DEVELOPMENT DETERMINATION PANEL MEETING

WEDNESDAY 8 NOVEMBER 2023

ITEM 3.1	DA2023/0455 - 1 PHYLLIS STREET NORTH CURL CURL - ALTERATIONS AND ADDITIONS TO A DWELLING HOUSE
REPORTING MANAGER	Rodney Piggott
TRIM FILE REF	2023/709160
ATTACHMENTS	1 ↓ Assessment Report 2 ↓ Site Plan and Elevations 3 ↓ Clause 4.6

DEVELOPMENT APPLICATION ASSESSMENT REPORT

Figure 2. Building height diagram - bedroom 4 non-compliance.

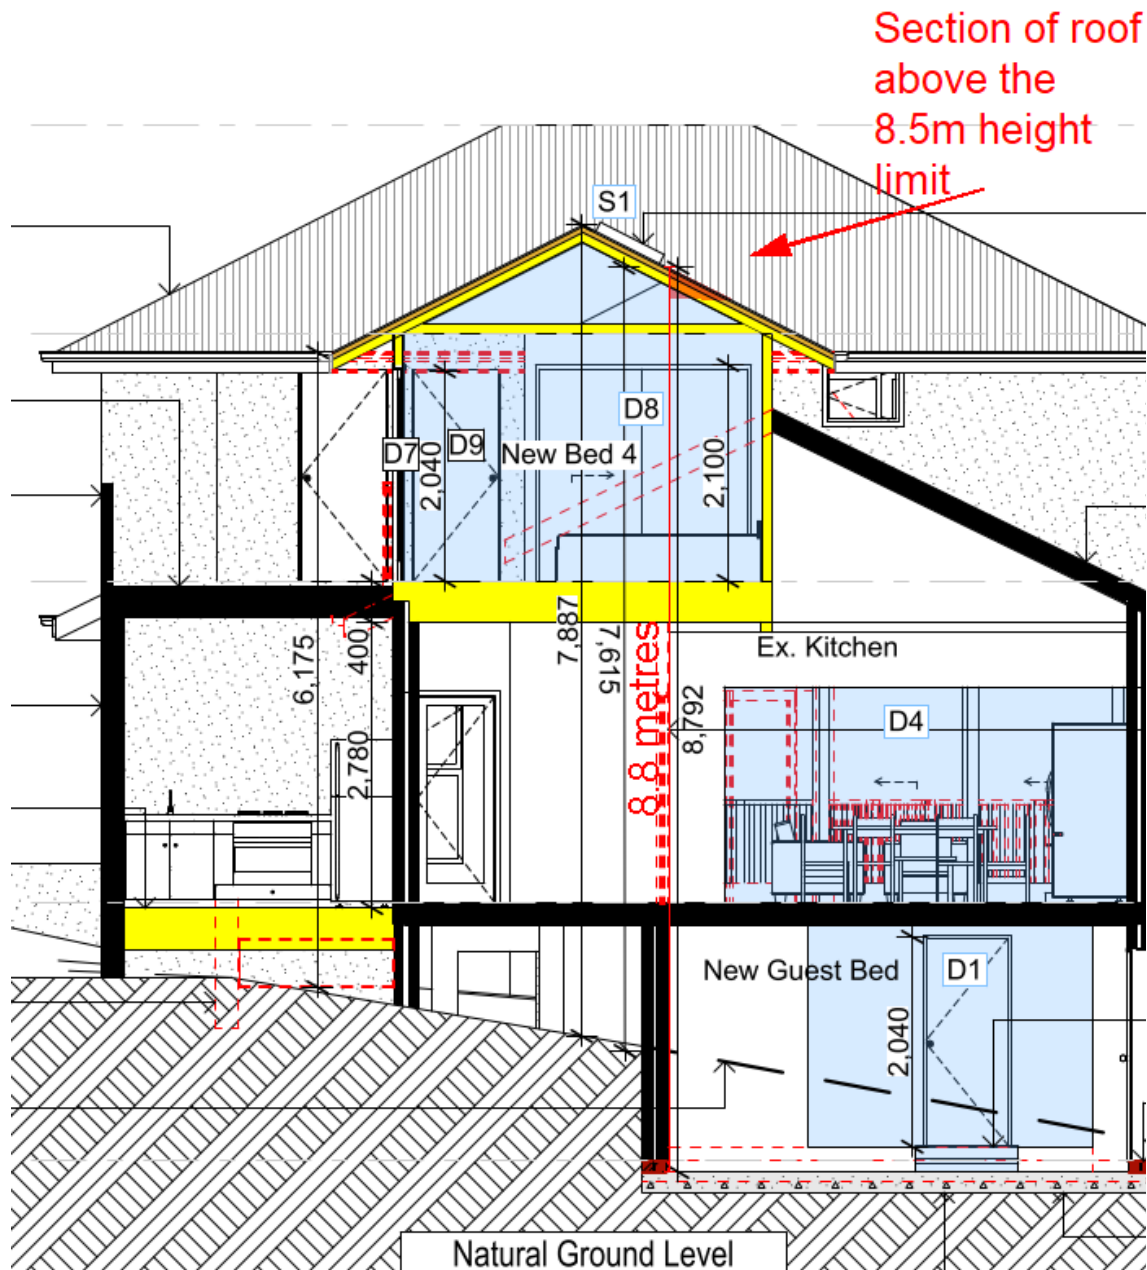
The projections above the 8.5 metres height limit are limited to the front and rear of the building with minor areas of the pitched roof (demonstrated in figures 1 and 2 above). As above, this is largely consequence of existing excavation and the proposal would comply if measured from the extrapolated natural ground levels. Notwithstanding, the proposed first floor extension has been amended to provide a generous secondary front setback so that the additions are adequately concealed behind the existing balcony. Overall, the proposed height is considered to be compatible and commensurate with the existing built form and therefore, remains consistent with the height and scale of surrounding and nearby development.

Figure 3. Wall height non-compliance.

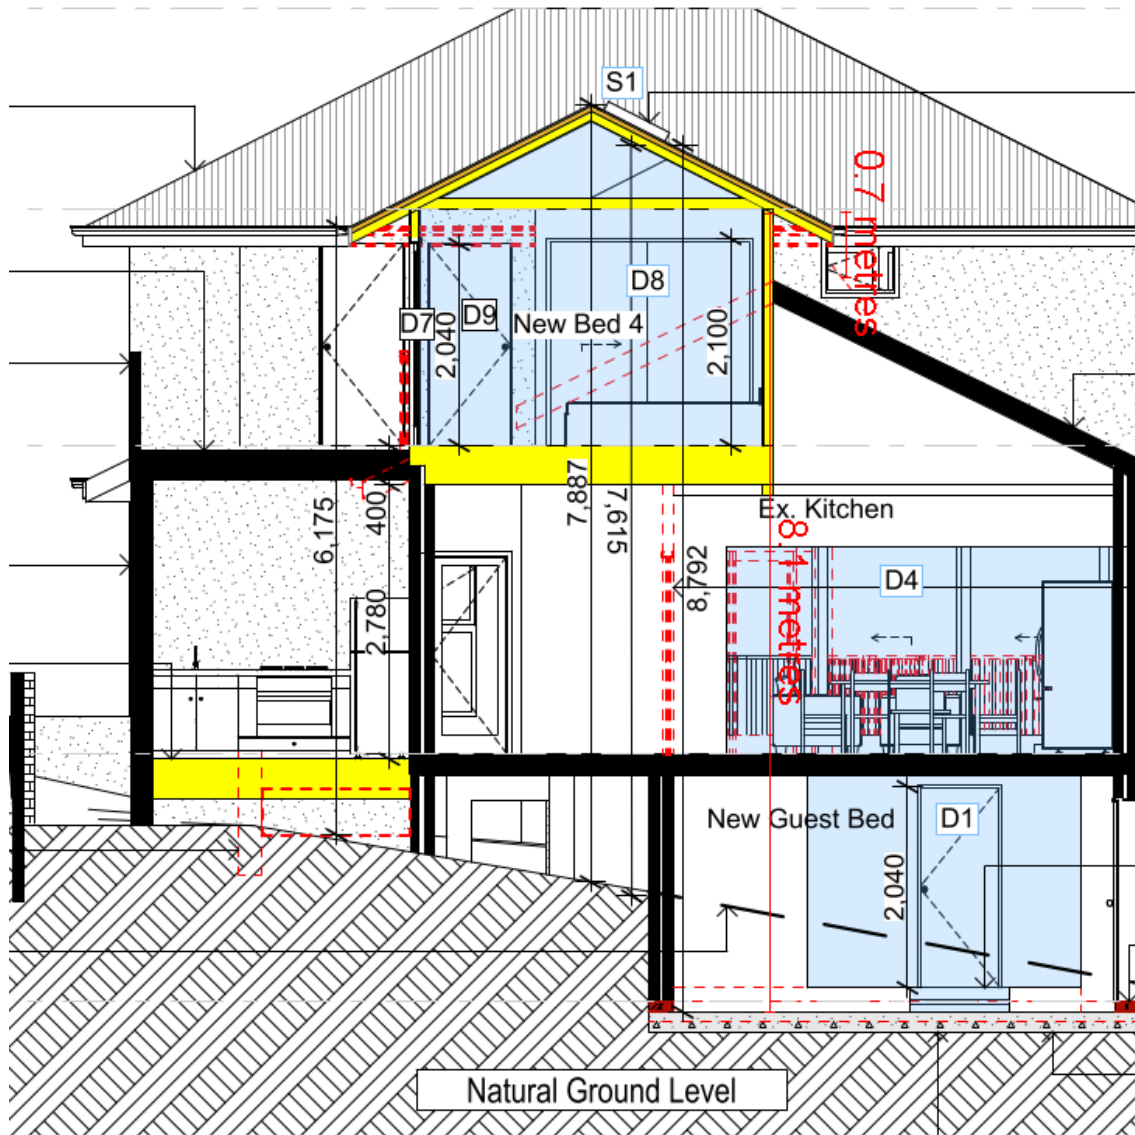
The DCP requires a maximum wall height of 7.2 metres. The proposed development has a maximum wall height of 8.1 metres at its highest point.

Figure 4. Extent of eastern side boundary envelope non-compliances.

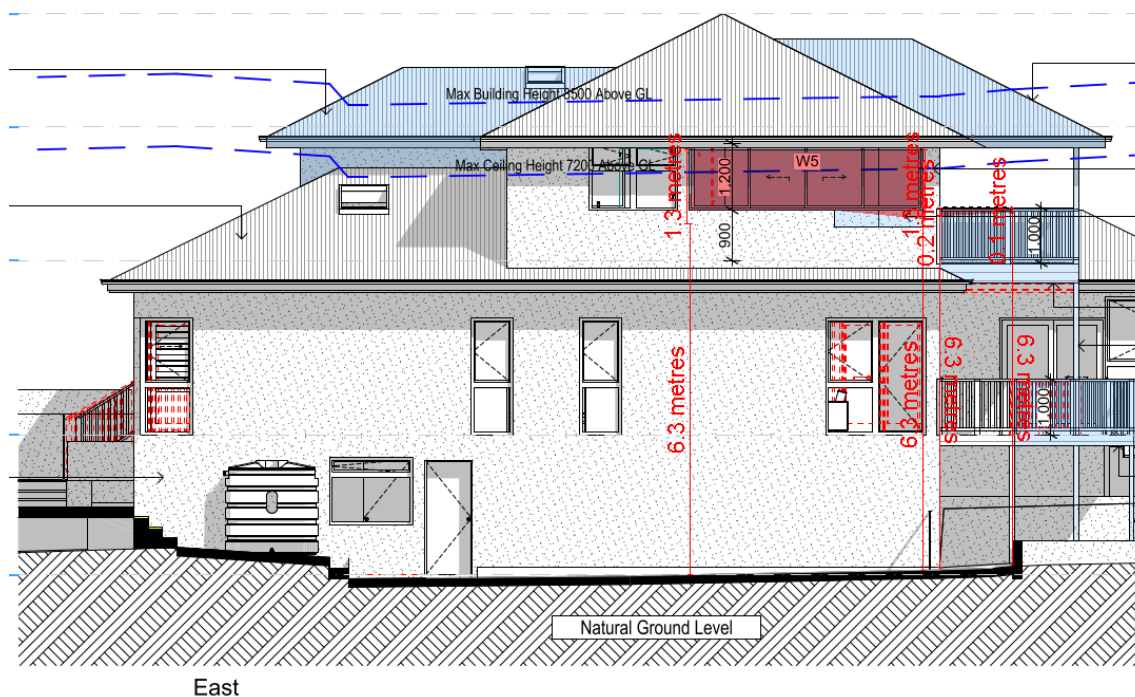
- Master bedroom windows - sized 1.3 metres in height for a length 4.2 metres. This represents a variation of 26%.
- Master bedroom balcony - between 0.1 metres and 0.2 metre for a length of 1.3 metres. This represents a maximum variation of 4%.

Figure 5. Front setback non-compliance.

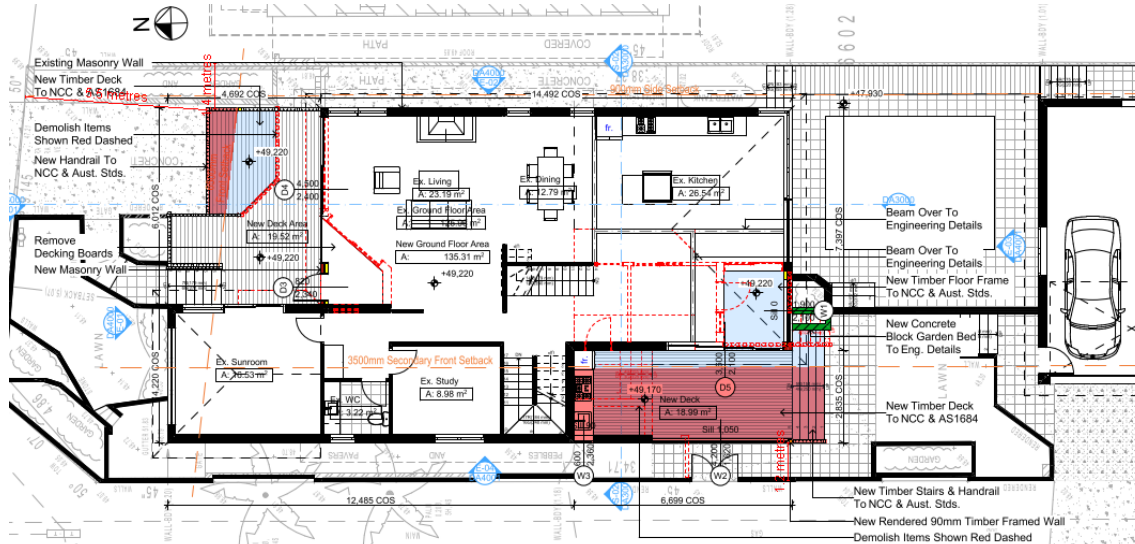
The proposed north facing deck is set back at a minimum of 5.5 metres from the Phyllis Street boundary. The ground floor BBQ area is set back 1.2 metres from the Ian Avenue boundary.

Figure 1 - Extract from plans showing 8.5m height blanket.

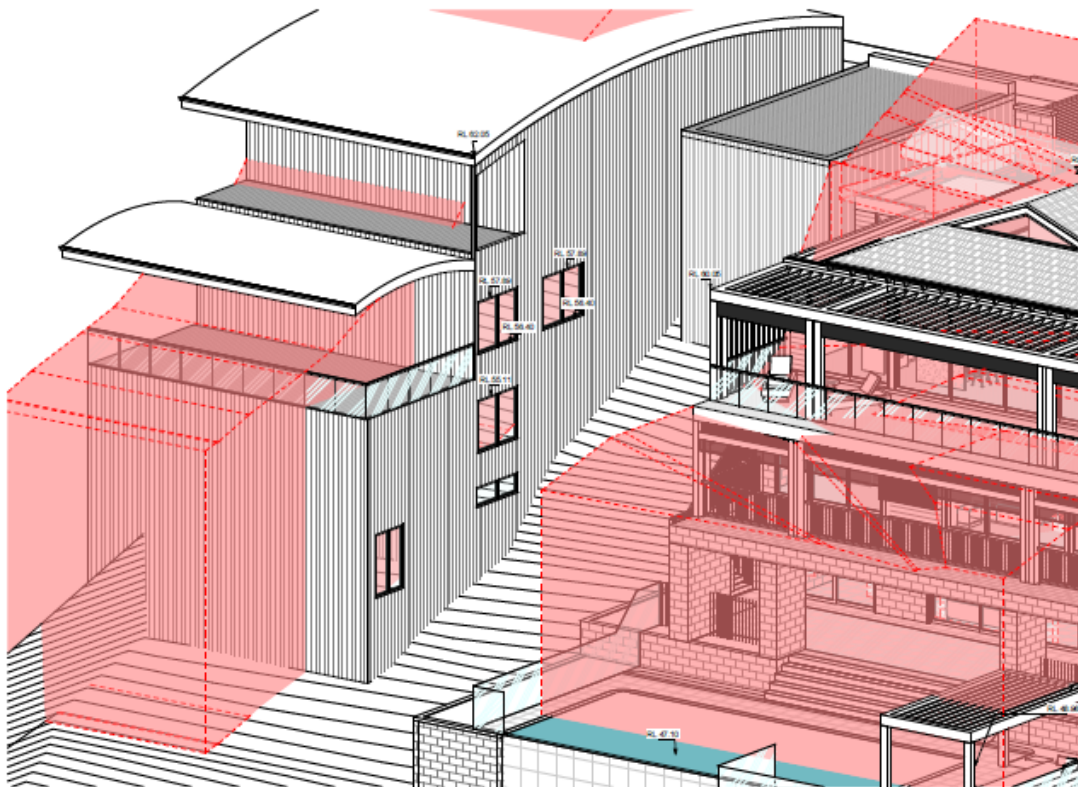
Development standard:	Height of buildings
Requirement:	8.5m
Proposed:	6.2m to 11m
Percentage variation to requirement:	29.4%

Figure XX - Red line represents alignment of breaching top floor balcony, sitting behind the alignment of the adjoining two buildings.

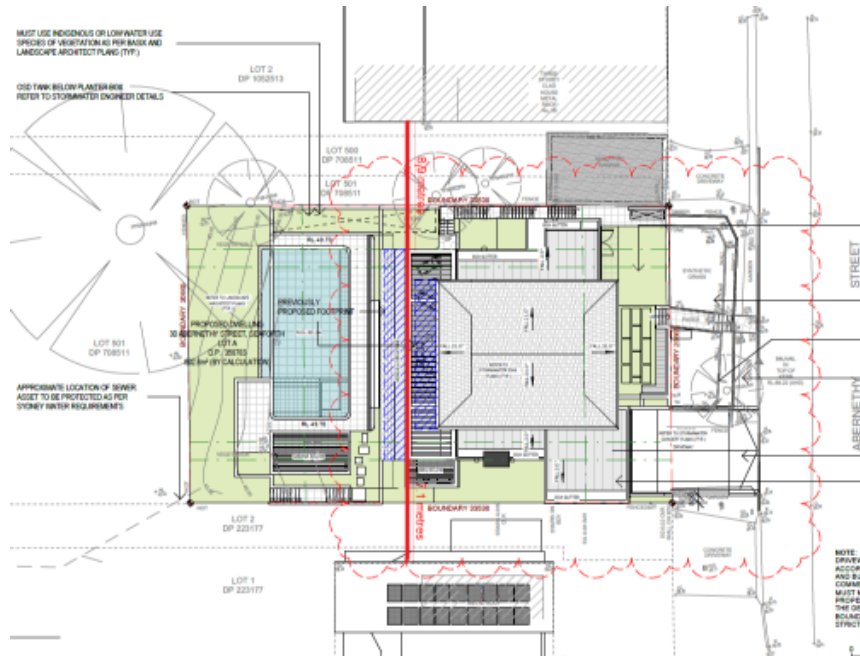
It is also noted that the proposed upper level balcony is setback behind the alignment of the two adjoining buildings, therefore reducing the visual prominence of the building when viewed from the adjoining sites. This also promotes view sharing.

Figure 2 – Southern elevation showing the revised plans with increased setback to the western boundary and reduced ridge height of the roof form.

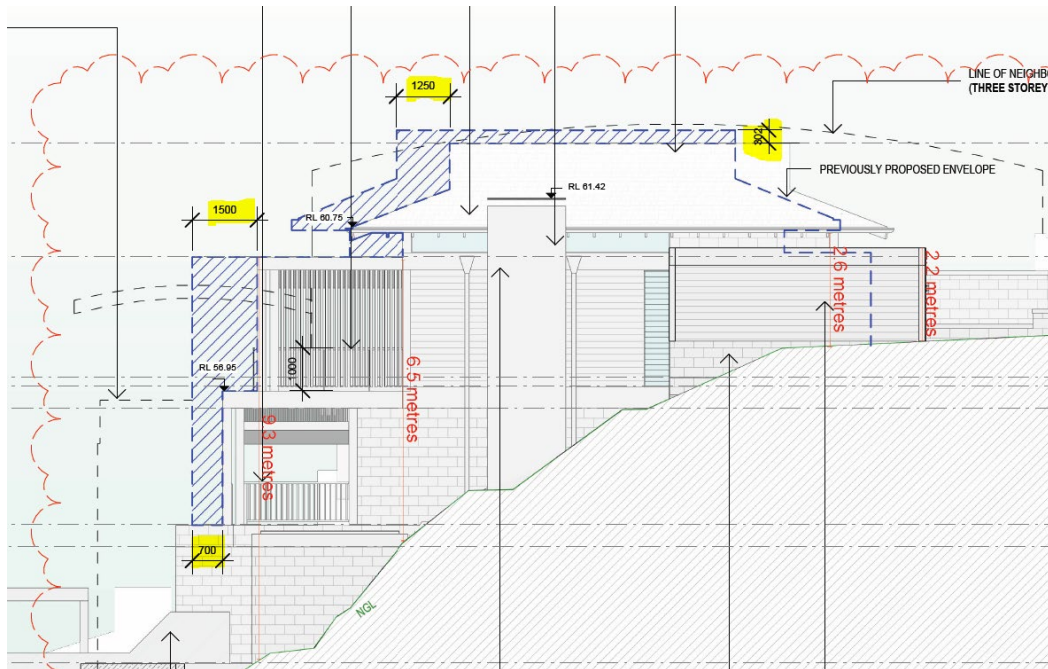
It is important to note that the location of the height poles **represent the original plans as submitted**. The amended plans reduce the height of the central roof pitch by 302mm and move the roof 1.25m closer to the front (eastern) boundary. The upper-level pergola is also setback 1.5m and the lower-level pergola setback 0.7m.

Figure 18 – View from ground floor balcony, standing position looking south-west. Image taken from applicant's Clause 4.6 written request.

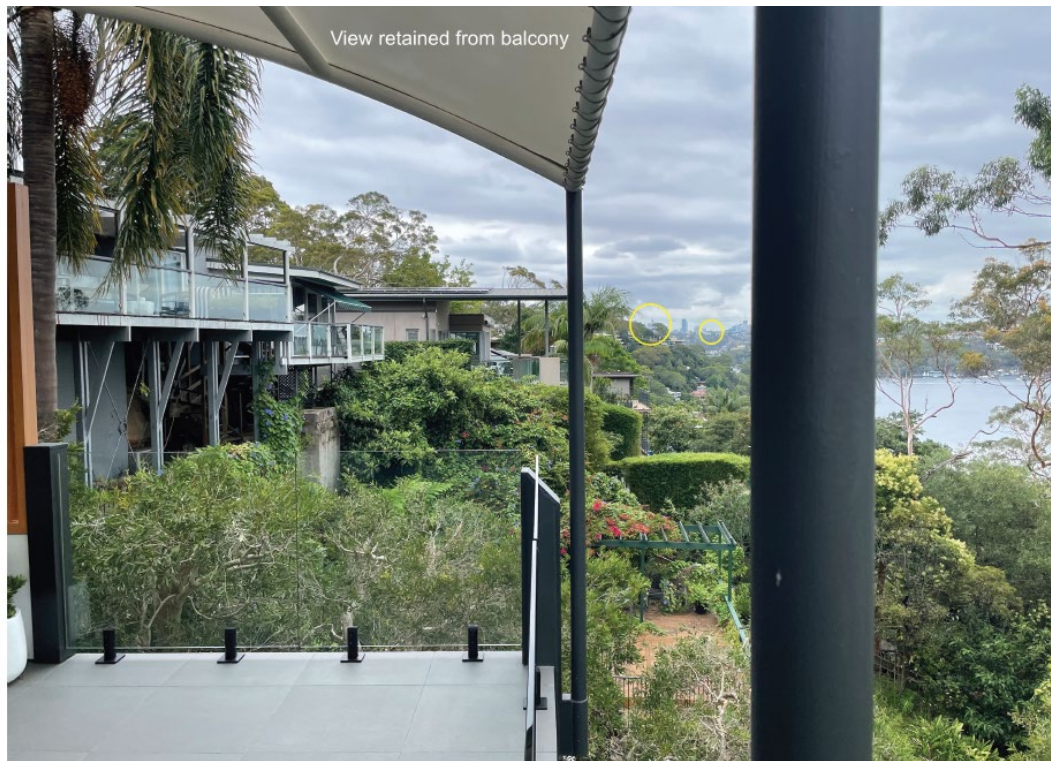
The city skyline views (including the harbour bridge and Centre Point tower) will be retained in full from the balcony when standing to the west of the privacy screen (Figure 18).

Figure 20 – Extract of plans showing the alignment of the building relative to the two adjoining buildings.

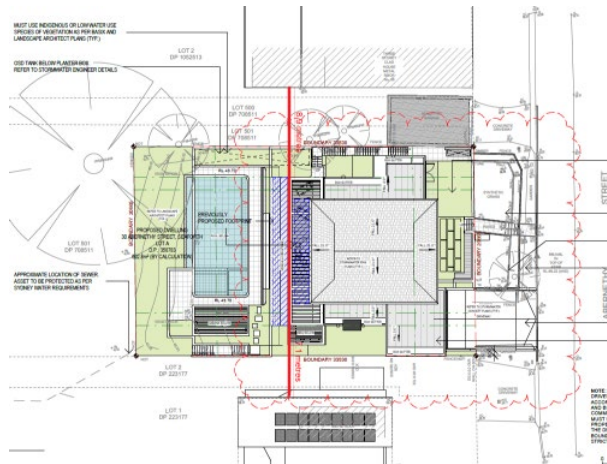
It is the western (rear) setback to the building which is the determining factor within regard to view retention of the CBD Skyline, Centre Point Tower and Harbour Bridge view. The DCP requires a minimum 8m rear setback. The proposed development has a rear setback of 15.2m to the upper-level terrace/balcony and 14.4m setback to the mid-level terrace/balcony. When looking at the alignment of the adjoining two buildings, the proposal is setback behind the predominant alignment of the two nearest buildings, as shown in Figure 20 below. In relation to 'view sharing', by pushing back the proposed dwelling further, this restricts views being obtained from the balcony of the subject site. The

Planning Principle is a principle of 'view sharing', not 'view retention'. Given that the 'iconic' view of the Harbour Bridge, CBD and Centre Point Tower will be retained across a side boundary from the balcony of 36 Abernethy Street and high quality views of middle harbour will be obtained from multiple rooms over the rear and side boundary of the site, this assessment finds that view sharing is achieved.

Figure 1. North-east elevation envelope breach under DA2023/0057 (extent of breach shown in yellow shading).

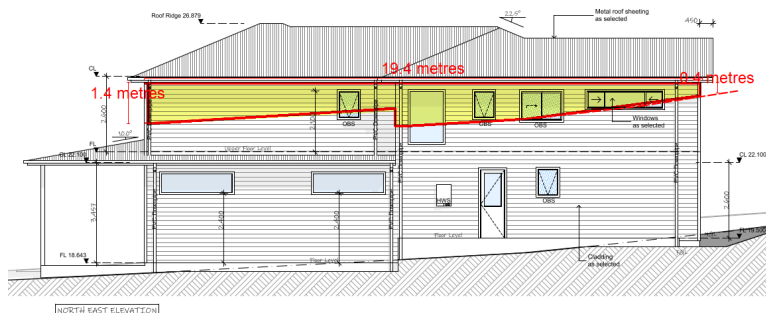
The original development application sought consent for a substantial breach to the building envelope along the north-eastern elevation (for a length of 19.4 metres, at a height ranging between 0.4 metres and 1.4 metres), as shown in the figure below.

Figure 2. North-eastern elevation envelope breach (extent of breach indicated in pink shading).

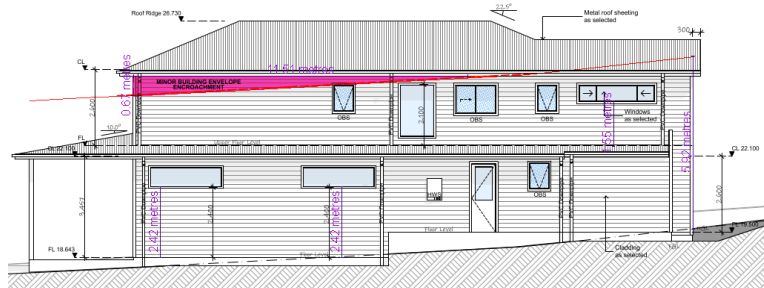
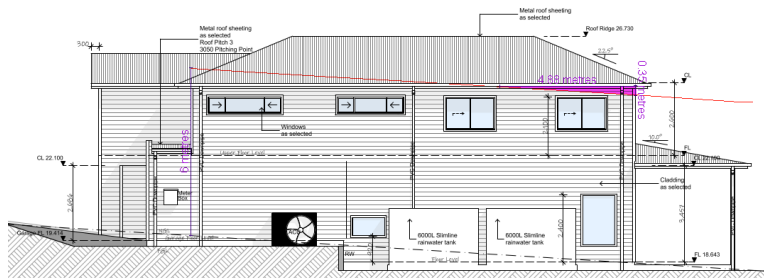
The amended architectural plans under this review application indicate a considerable reduction to the envelope breach (as has been shown within this report under section D1.11 Building envelope) so as to address this reason for refusal. Amended stormwater plans were provided which were reviewed by Council's Development Engineer, who are now satisfied that the proposed stormwater management is acceptable, subject to recommended conditions. By virtue of these amendments, the proposed development is now within the public interest.
